SUBJECT: R.E. GINNA NUCLEAR POWER PLANT - ISSUANCE OF AMENDMENT RE:  
REVISION TO TECHNICAL SPECIFICATION SECTION 3.6.5, "CONTAINMENT  
AIR TEMPERATURE." (TAC NO. MF0900)

The amendment revises Technical Specification 3.6.5, "Containment Air Temperature," to increase the allowable containment air temperature from 120 °F to 125 °F.

Amendment No. 116  
Renewed License No. DPR-18

SAFETY EVALUATION BY THE OFFICE OF NUCLEAR REACTOR REGULATION

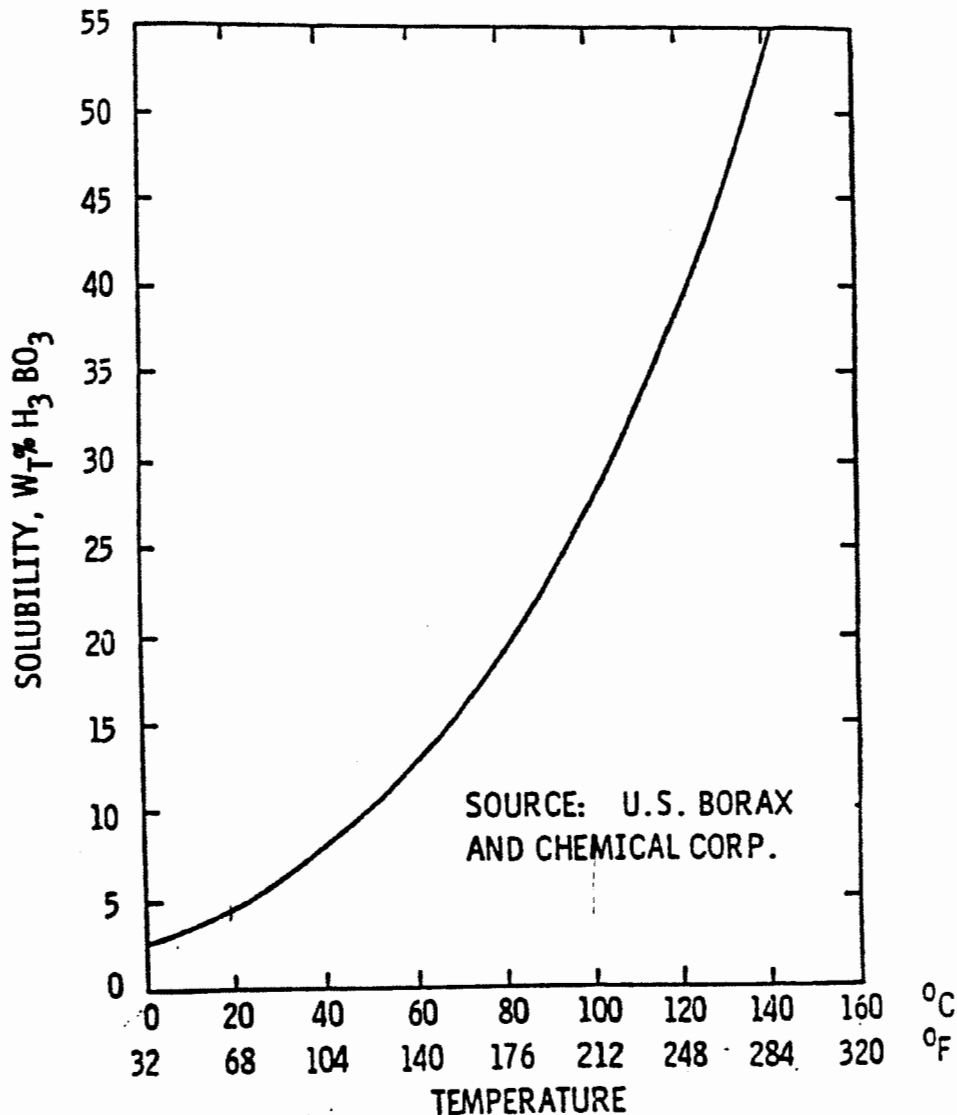
For break sizes 4-inches and larger, accumulator injection is required to prevent the core from becoming uncovered. In these cases, the accumulator flow rate is the dominating factor in the analyses. The amount of water entering the RCS to fill the downcomer and core and mixing with the cold leg fluid that is much hotter outweighs the 5 °F increase in accumulator temperature. This leaves the 2-inch break size as the limiting case.

For the 3-inch break size where accumulator injection occurs only 75 seconds before PCT, core recovery depends on the timing of accumulator injection. If the accumulator temperature increases, fuel temperatures increase for a longer period of time once SI injection occurs. This will ultimately cause PCT to increase. The PCT for a break size of 3 inches is 1117 °F. There is a 50 °F margin between this case and the limiting PCT of 1167 °F for the 2-inch break. The result of a 5 °F increase in accumulator temperature will have a negligible impact on PCT when compared to the 50 °F margin to the limiting PCT for this case. This is because, similar to break sizes of 4-inches and larger, the amount of mass entering the system and mixing with the cold leg fluid that is much hotter outweighs a 5 °F increase in accumulator temperature.

The licensee concludes that the PCT for an SBLOCA remains 1167 °F for a break size of 2 inches. Based on the above discussion, the NRC staff finds the results of the licensee's analysis acceptable.
